IMPACT OF DATA PRESENTED IN DRAFT  
NUREG-0630  
ON DONALD C. COOK UNIT 2 LOCA ANALYSIS

ATTACHMENT B  
TO  
AEP:NRC:00322B  
DONALD C. COOK NUCLEAR PLANT UNIT NO. 2  
DOCKET NO. 50-316  
LICENSE NO. DPR-74

Change No. 1 (Change No. 2 of AEP:NRC:00297)

Revisions to Limiting Condition of Operation (LCO) 3.2.2,  
Figure 3.2-2 and Basis Item 3/4 2.1 - Unit No. 2

FIGURE 3-2  $K(Z)$  - NORMALIZED  $F_Q(Z)$  AS FUNCTION OF CORE HEIGHT

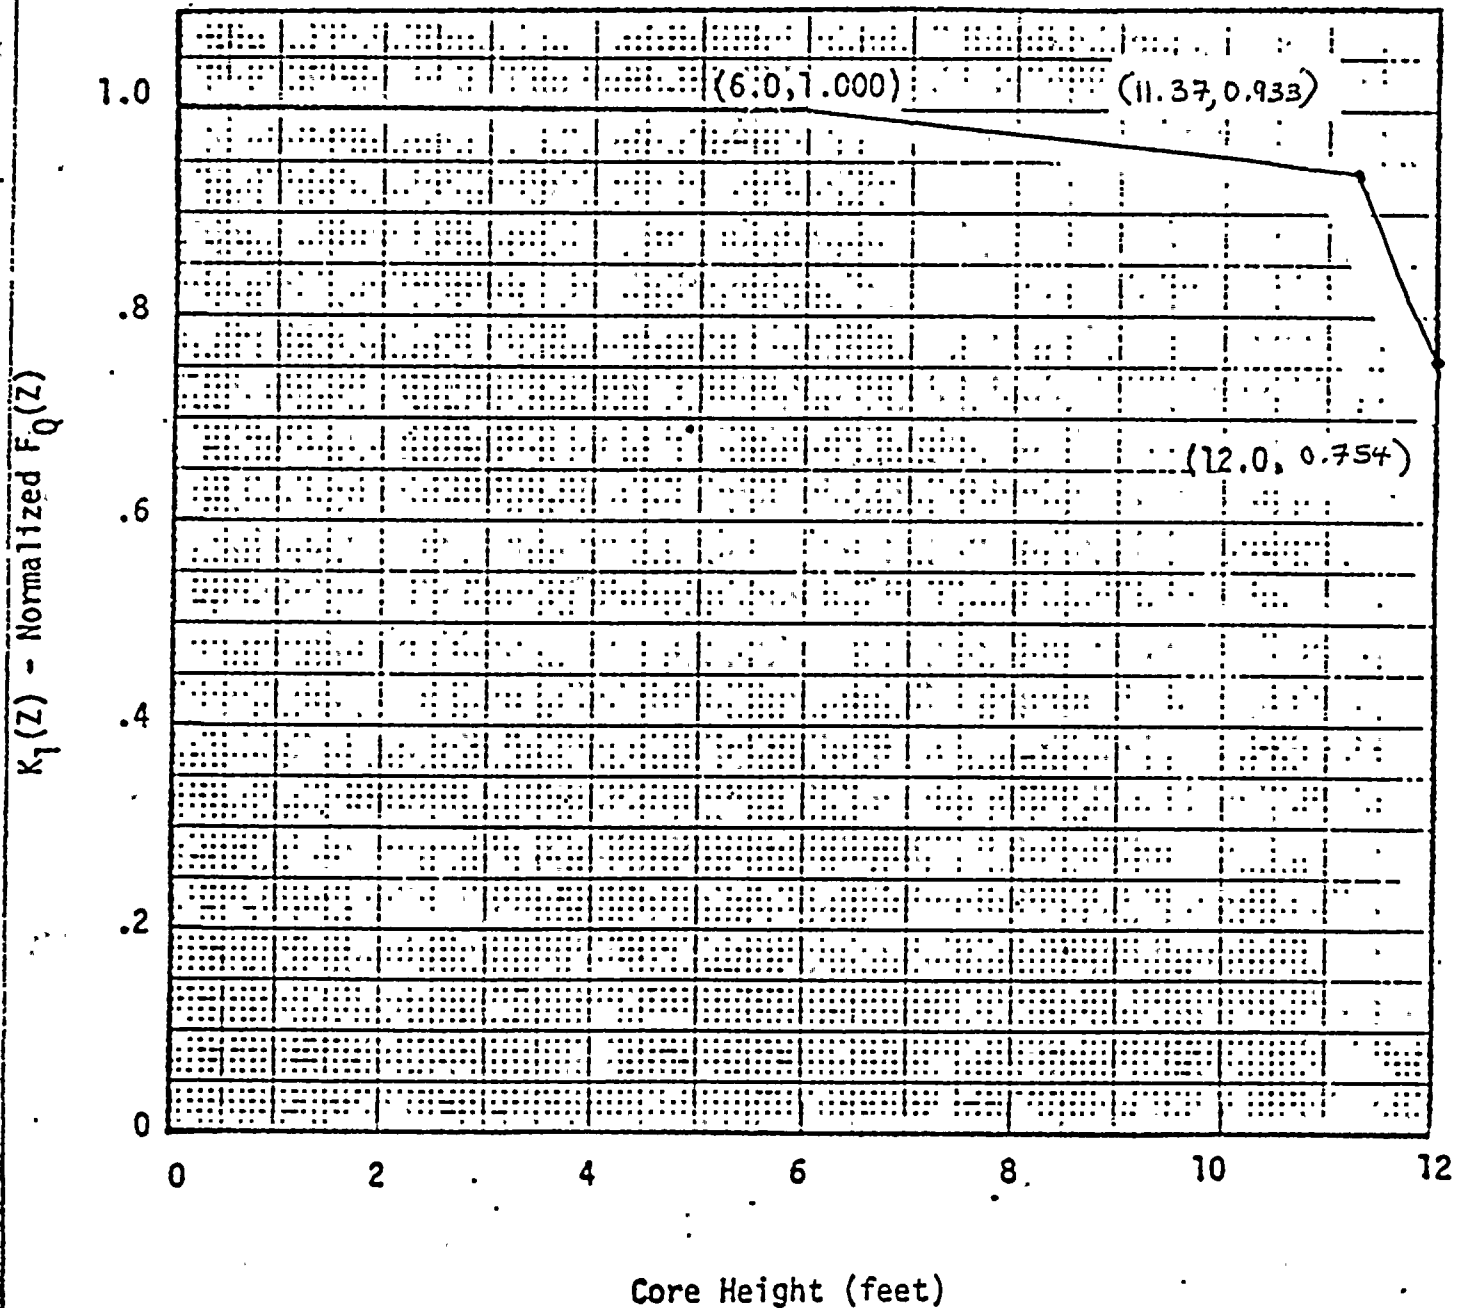
This change involves lowering the maximum allowable  $F_Q$  (Z) limits. The maximum value is being reduced from 2.32 to 1.99. Until the 1.99 limit was established via the evaluation discussed in Attachment A of this letter, an administrative limit of 2.11 was employed in compliance with the NRC order which followed the discovery of a 'logic inconsistency' in the metal-water reaction calculation of the Westinghouse ECCS Evaluation Models. The 2.11 administrative limit was established after a new Westinghouse ECCS analysis (using the October 1975 Model with the metal-water correction) was performed. These analyses results were transmitted to the NRC on April 28, 1978. A reanalysis of Donald C. Cook 2 using the February 1978 Model resulted in a maximum  $F_Q$  of 2.02. This base analysis was used to establish the new 1.99 limit. This change assures the continued protection of the public health and safety.

Basis:  $F_Q(Z) \times P$  ECCS limit of 1.99

FIGURE 3.2-1 AXIAL FLUX DIFFERENCE LIMITS AS A FUNCTION OF RATED THERMAL POWER

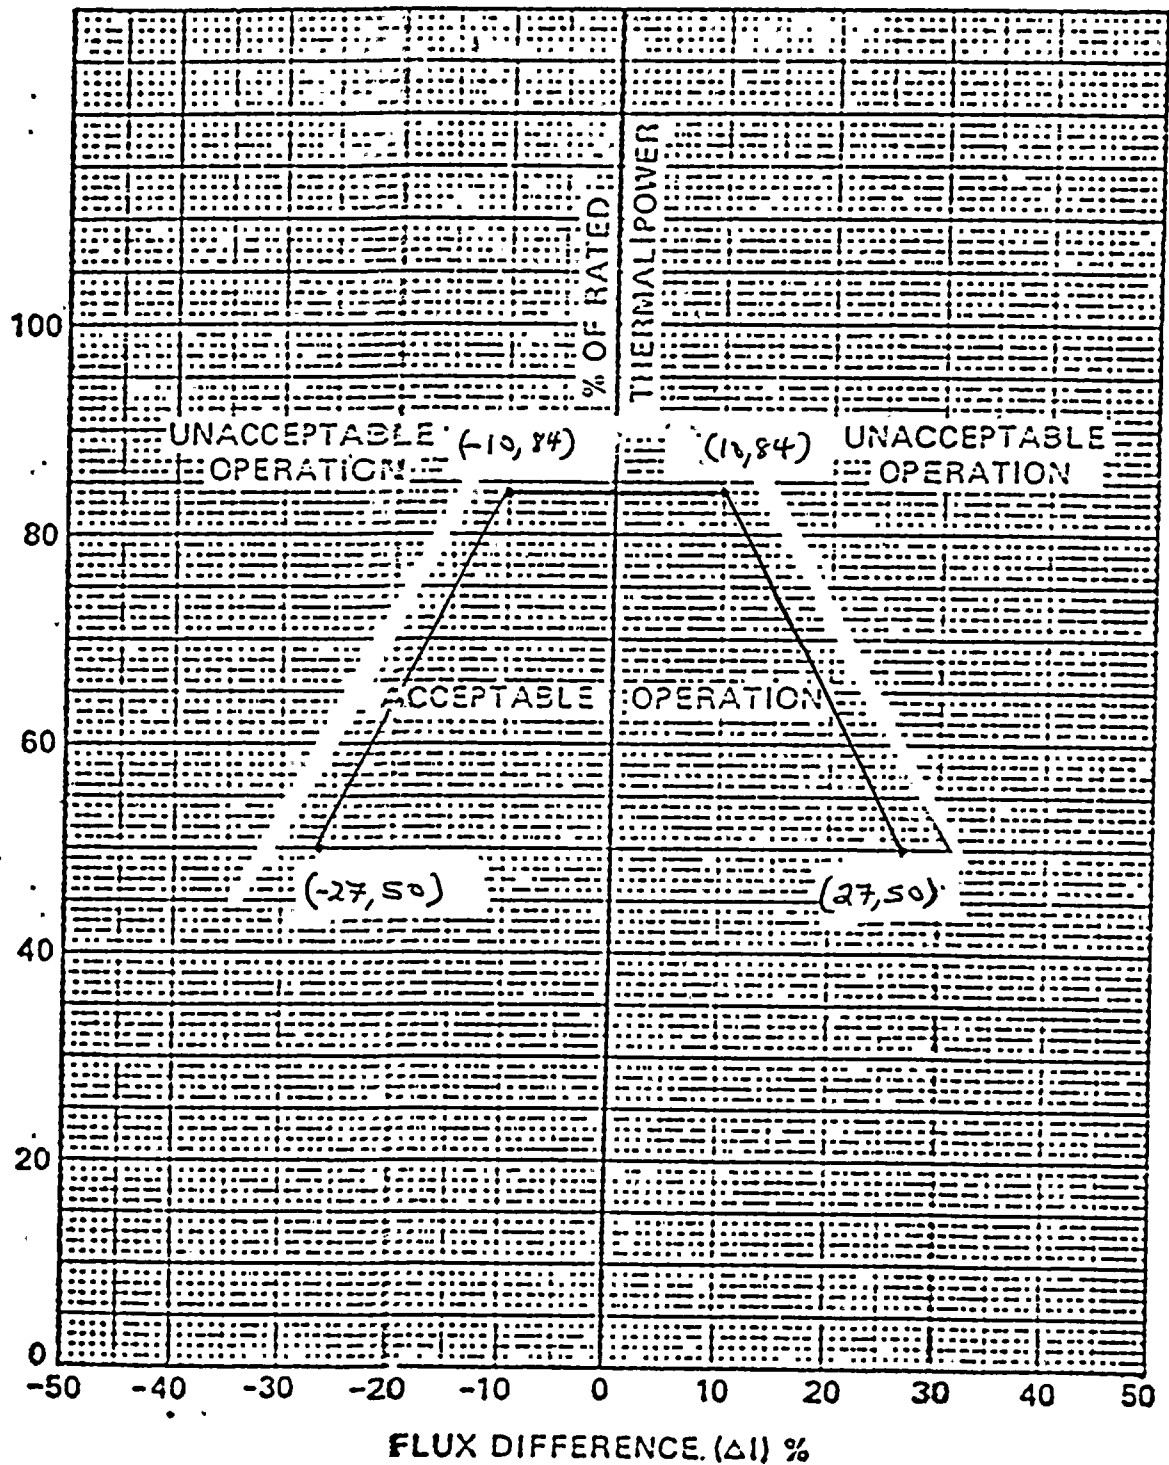
Revisions to LCO 3.2.1 and Figure 3.2-1 - Unit No. 2

This change involves keeping the upper power limit for the taking of action at 84% Rated Thermal Power. The change requested in AEP:NRC:00297 was to raise the limit to 90% RTP. This technical basis for the change is the same as that of Change No. 1 above. This change assures the continued protection of the public health and safety.
